Pleasanton Road at Medina River 12-Inch Water Main Replacement

Solicitation Number: B-14-057-GC

ADDENDUM 1

September 18, 2014

WATER MAIN - PLAN VIEW AND NOTES

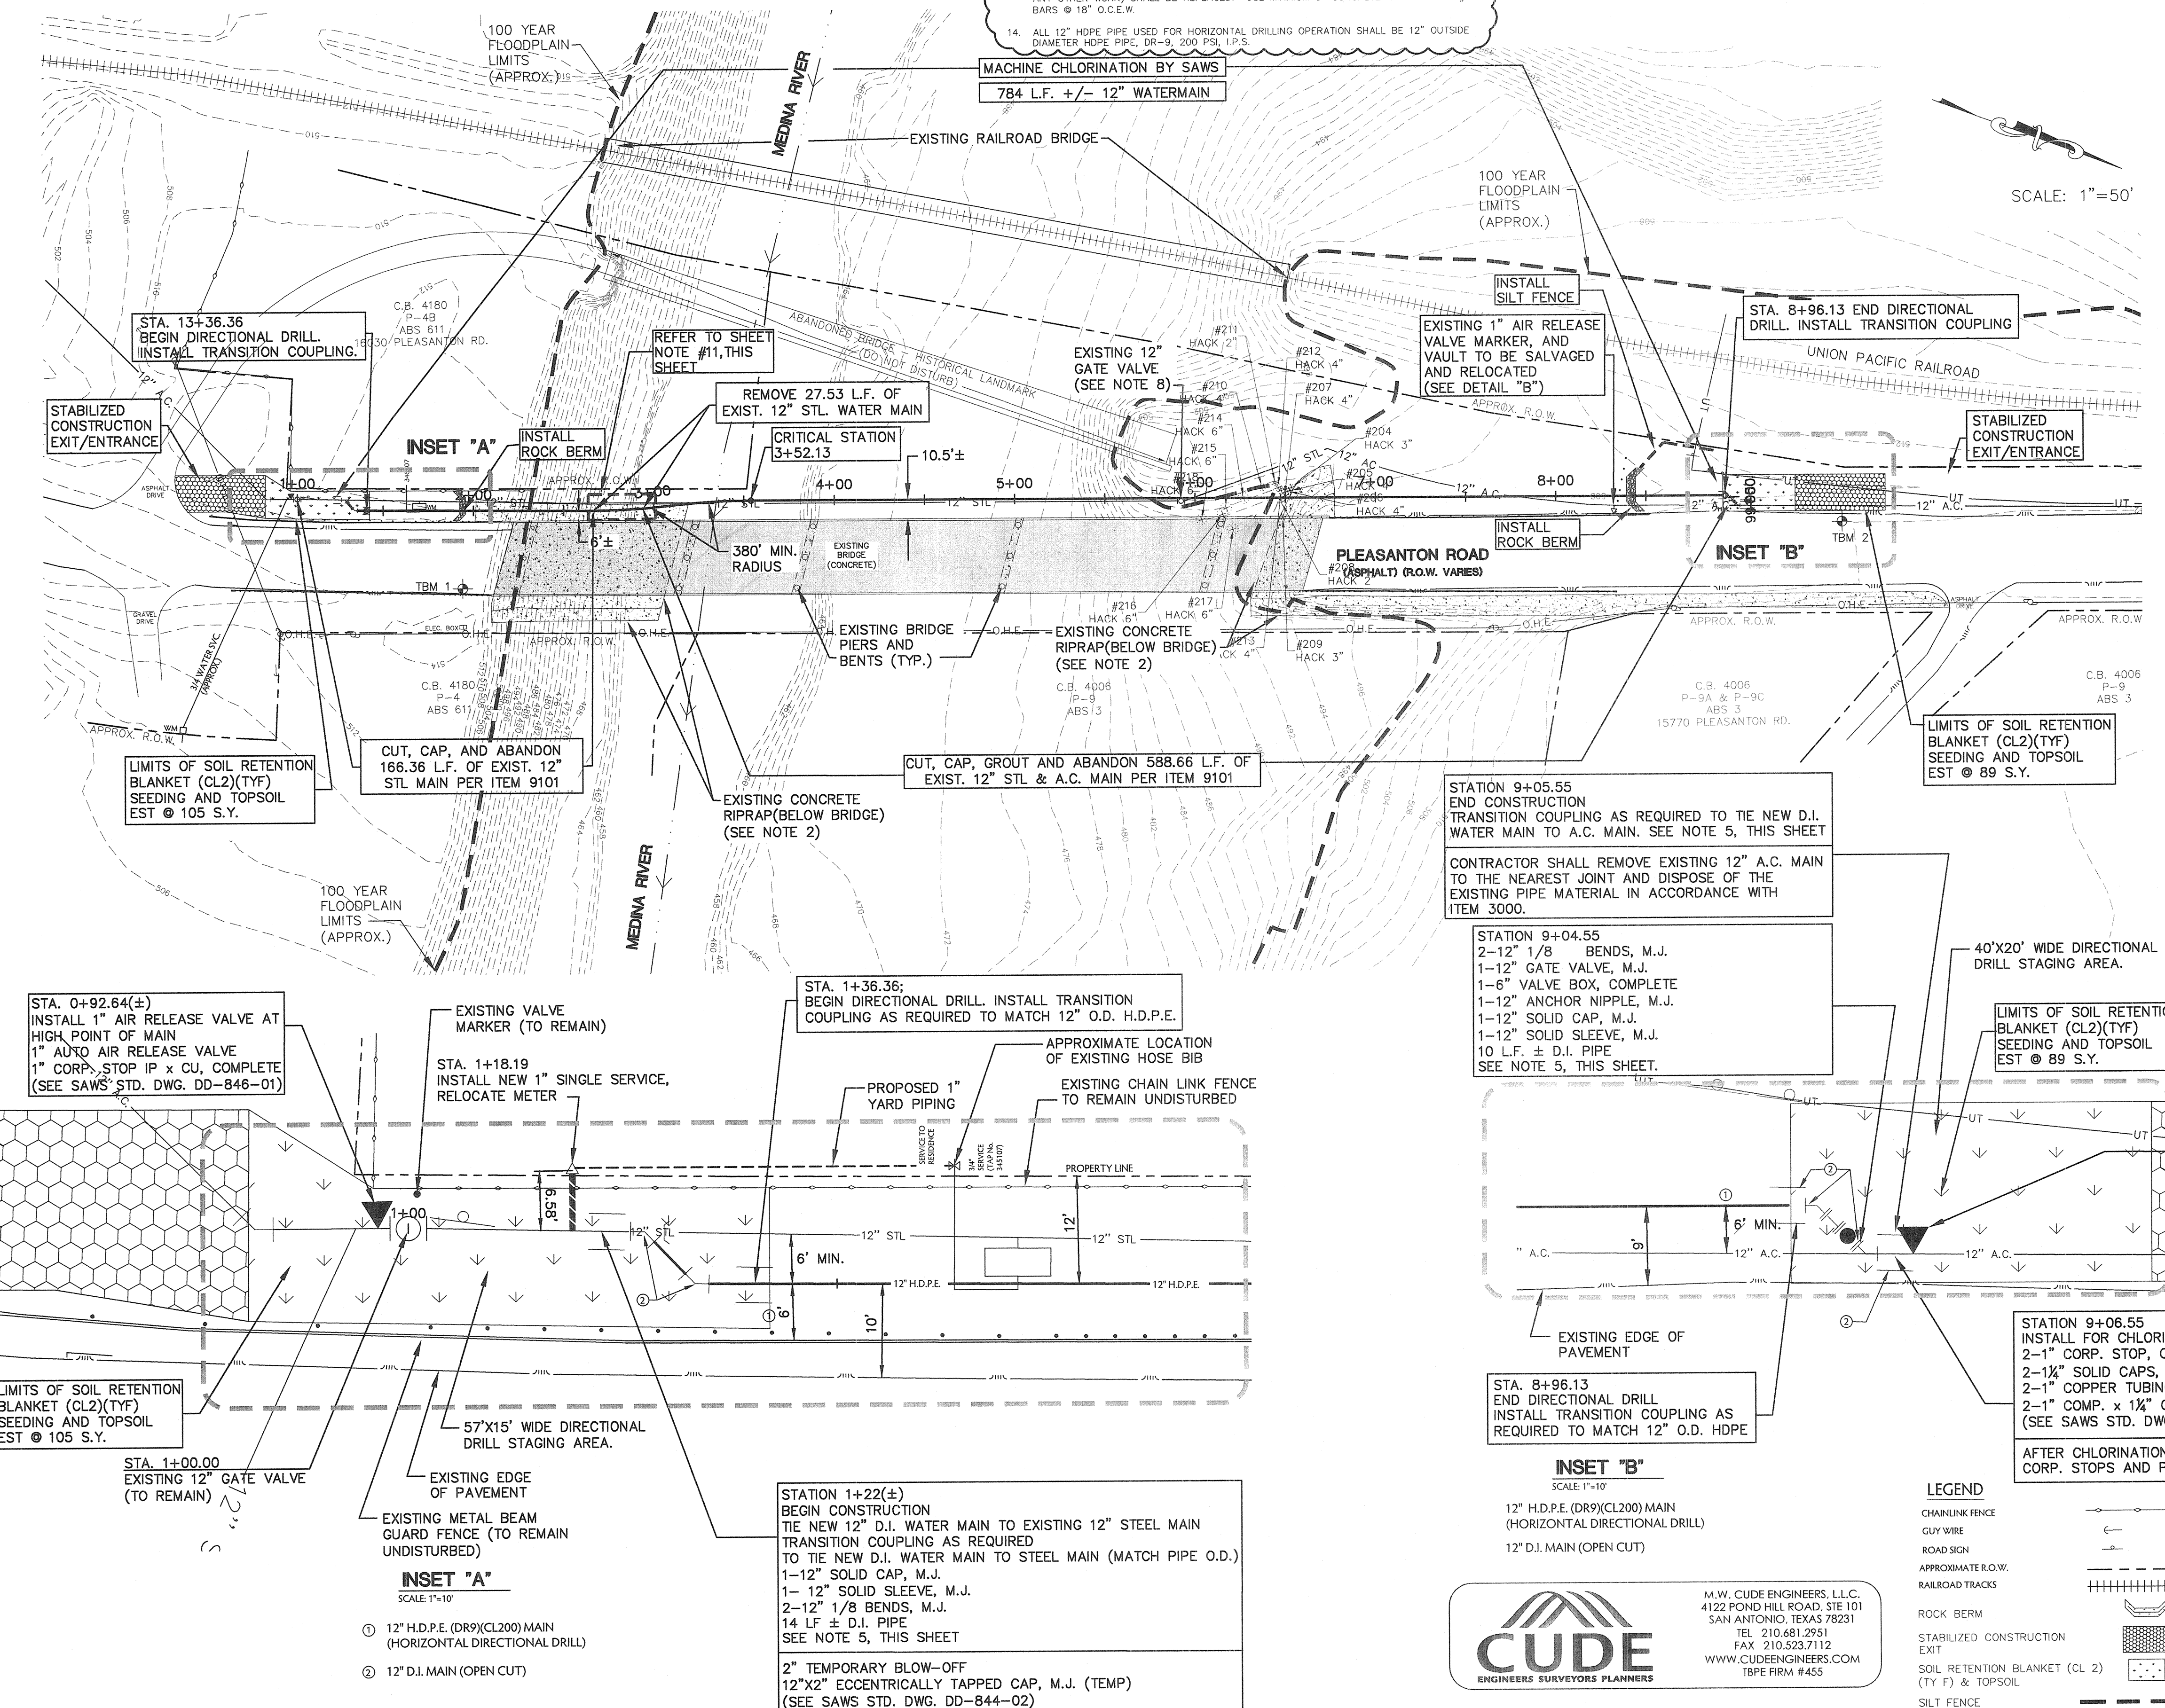
1. Sheet 3 of 6 – Added Floodplain notes & correct pipe size notes to the plan sheet.

- ANY SOIL THAT IS DISTURBED WITHIN THE FLOODPLAIN SHALL BE REVEGETATED WITH SOIL RETENTION BLANKETS, SEEDING AND TOPSOIL.
- ANY CONCRETE RIP RAP REMOVED OR DAMAGED DURING REMOVAL OF GATE VALVES (OR ANY OTHER WORK) SHALL BE REPLACED. USE MINIMUM 5" CONCRETE RIP RAP WITH #3 BARS @ 18" O.C.E.W.

- ALL 12" HDPE PIPE USED FOR HORIZONTAL DRILLING OPERATION SHALL BE 12" OUTSIDE DIAMETER HDPE PIPE, DR-9, 200 PSL, I.P.S.
